TDG Ref: 12834.001
27 February 2015

North Kumutoto Precinct Project
Response to WCC Request for Further Information

Council's Request dated 5 February 2015 seeks further information and clarification on a number of urban design, traffic and related matters.

Carpark Ramp
1:50 @ A1 ; 1:100 @ A3

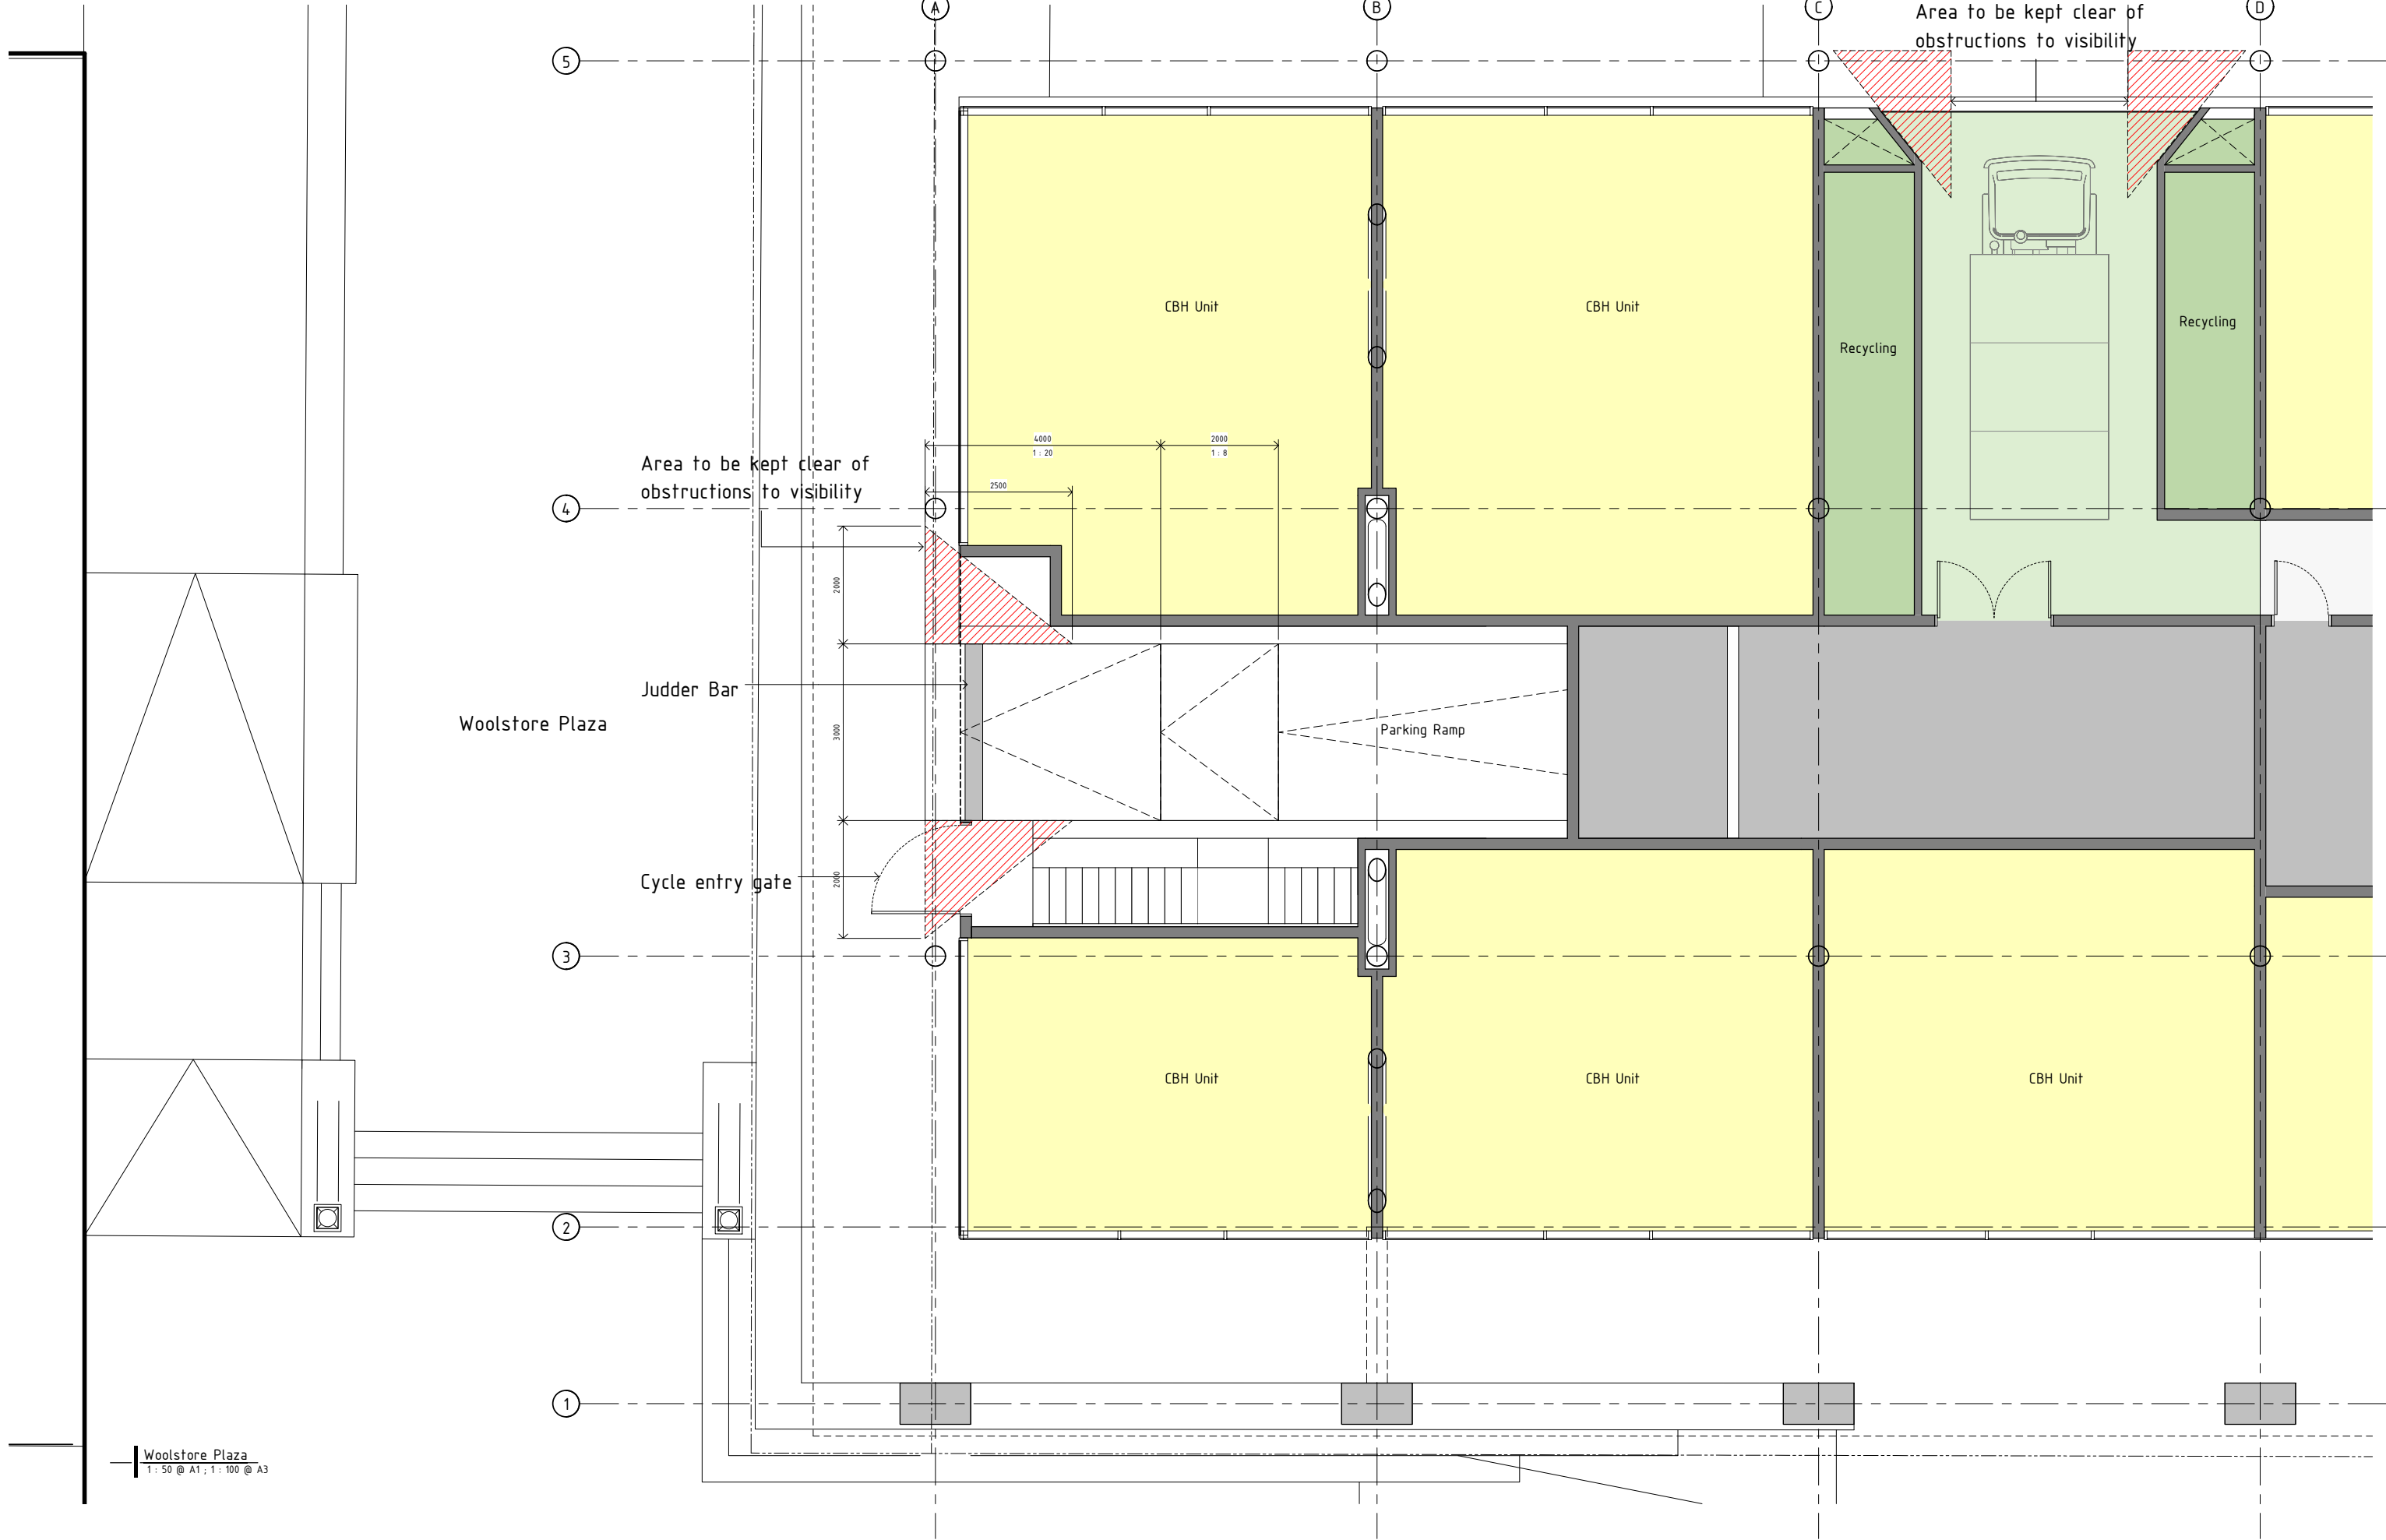
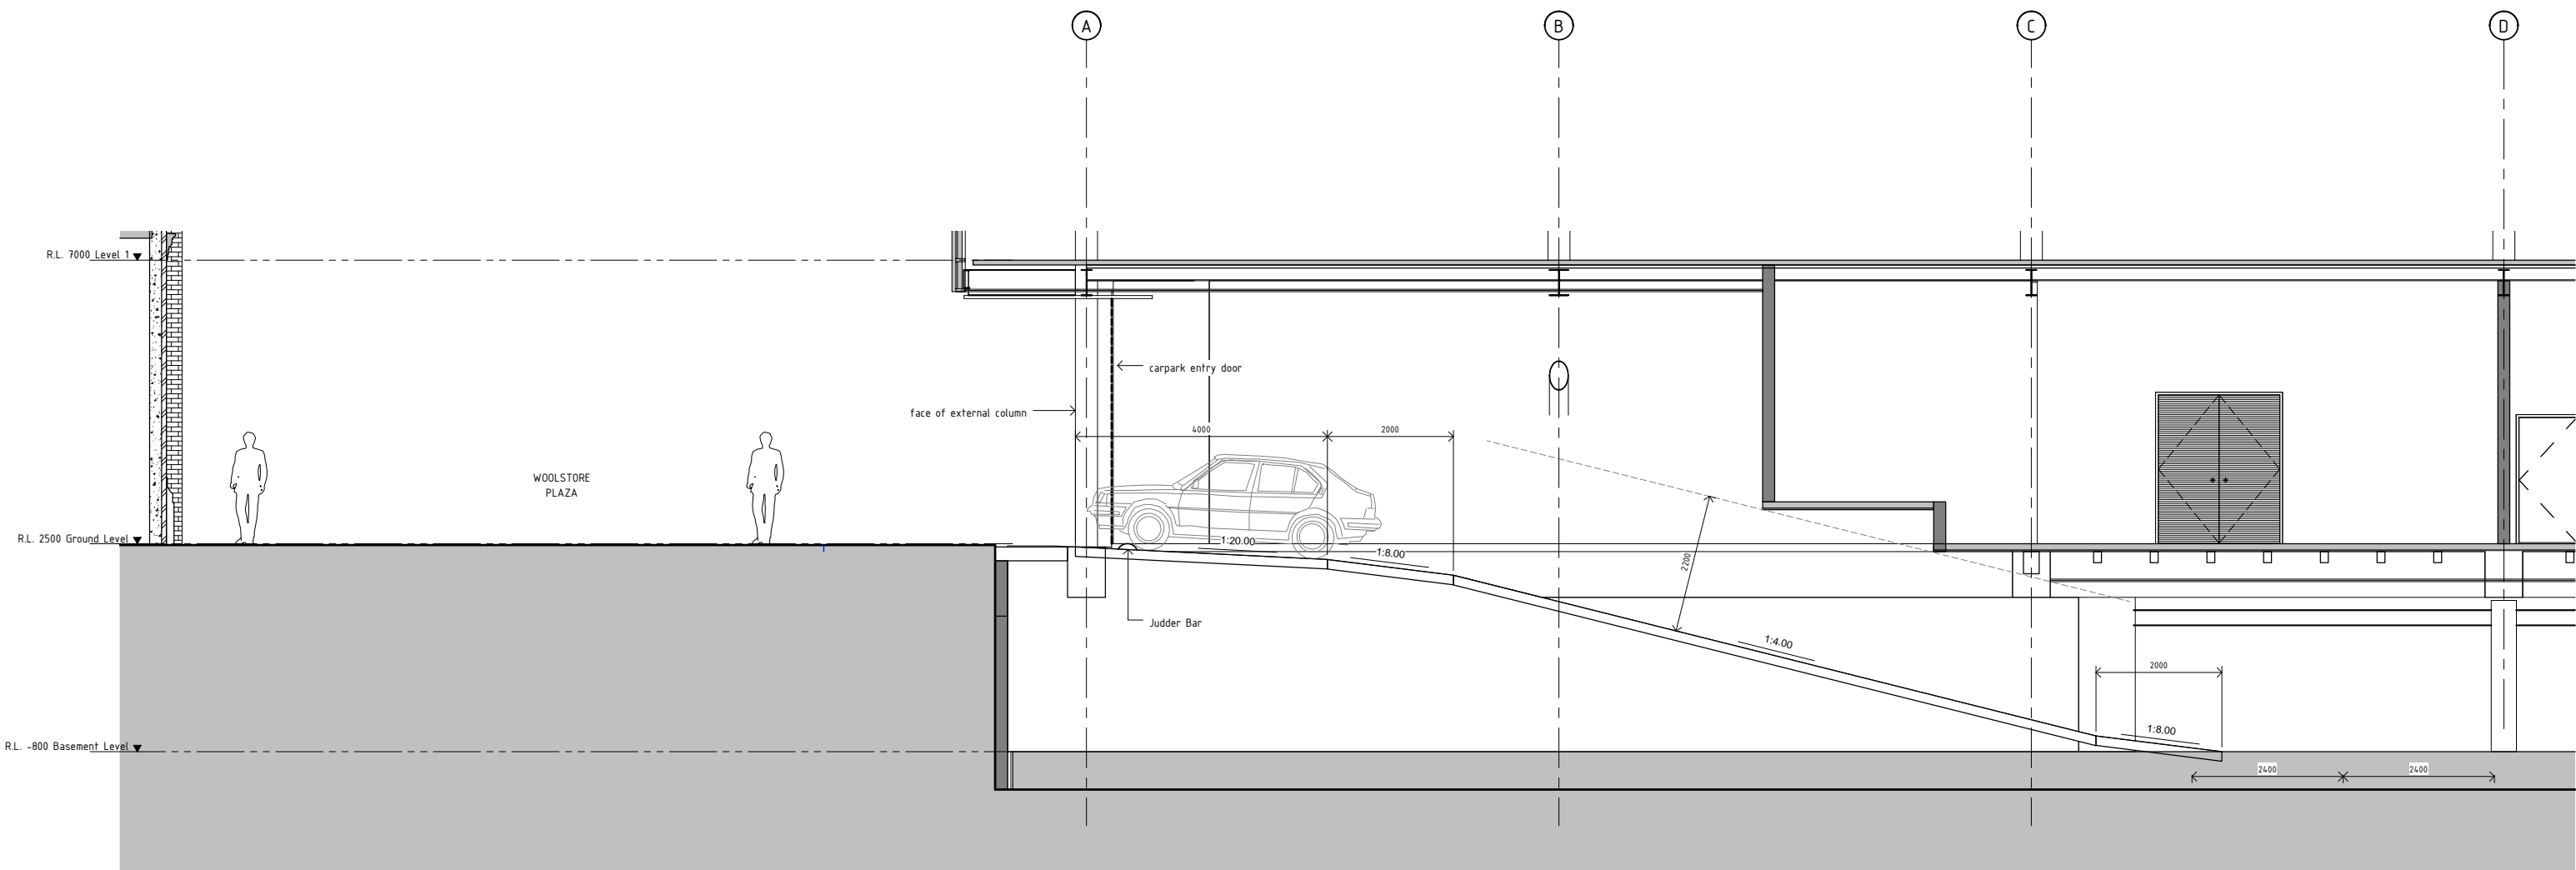
- 17.** *Please explain what measures will be implemented to ensure that vehicles exiting the parking ramp will not compromise public safety. These could include measures to warn pedestrians along the building edge of exiting vehicles (via an audible and/or visual system), as well as signal controls for users of the one-way ramp for entry and exit.*

- 23.** *Please provide details of the proposed gradient(s) into the basement level.*

Following the 10 February meeting, a careful review has been undertaken of the carpark ramp, and an updated design developed that presents a safer interface with the Wool Store Plaza.

The developed design incorporates:

- sight triangles in the manner anticipated by the District Plan, presenting required intervisibility between exiting drivers and pedestrians;
- a flat (1:20) grade at the top of the ramp on which vehicles can wait momentarily before exiting the building, should drivers need to yield to pedestrians;
- a roller door that will function as a control point, with an audible sound when it opens and closes that will heighten the awareness of users in the area;
- a judder bar positioned just inside the roller door, that will present a slow control point for vehicles before exiting onto the Plaza space;
- an external electronic 'Car Coming' sign that will alert users of the Plaza when cars exit; and
- traffic signals to control inbound and outbound movements on the single – width ramp. These signals will rest in green for inbound vehicles.

SK_05-D included earlier at Appendix F shows the updated carpark ramp, which has been designed with the following grades:

- a 1:8 transition from the basement carpark;
- a 1:4 central length;
- a 1:8 transition towards the top of the ramp; and
- a 1:20 flat section at the top in advance of vehicles exiting onto the Wool Store Plaza.

Plan Responding to Item 22

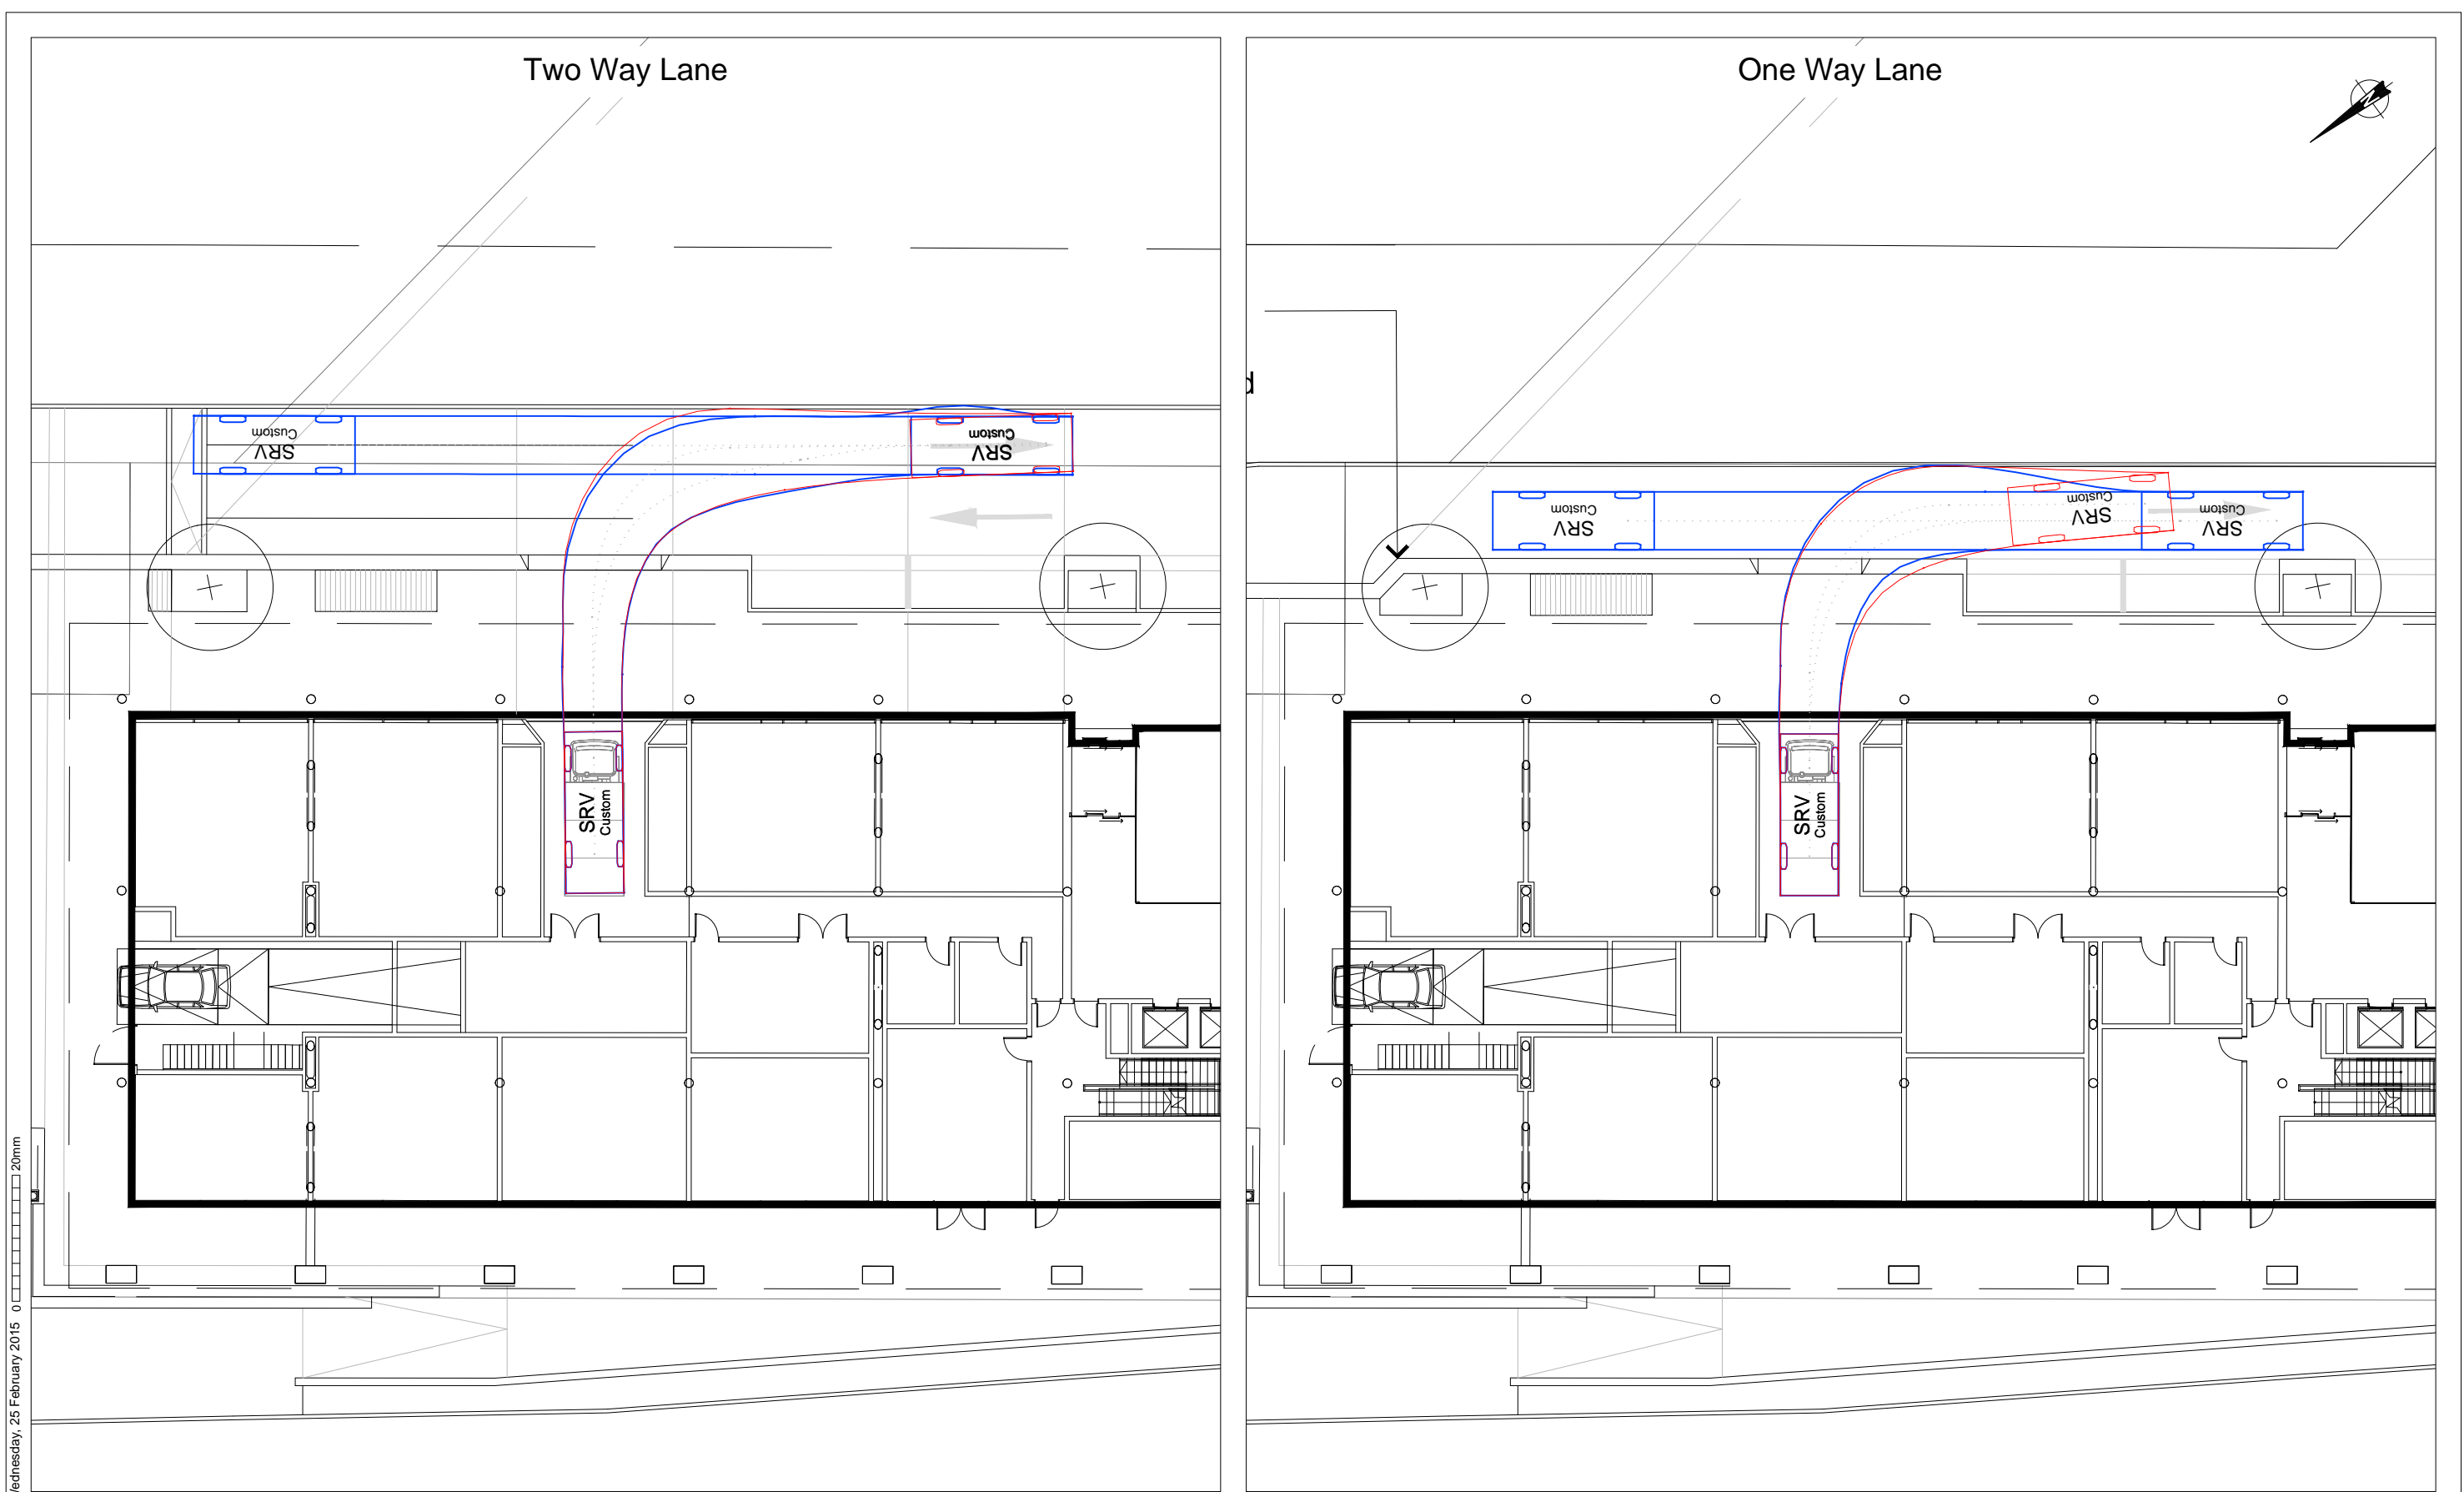
- 22.** *Please provide details on how users of the service dock will enter from, and exit onto the shared access lane safely (including tracking curves).*

The manoeuvres of a truck turning to and from the laneway (in both its two-way and one-way form) were illustrated by Figure 7 included in September 2014 Transportation Assessment Report. That diagram has been updated to reflect the new arrangements, and included as Figure 7A in Appendix G.

The arrangements show that driveway design changes will be needed in the event that a one-way lane is constructed.
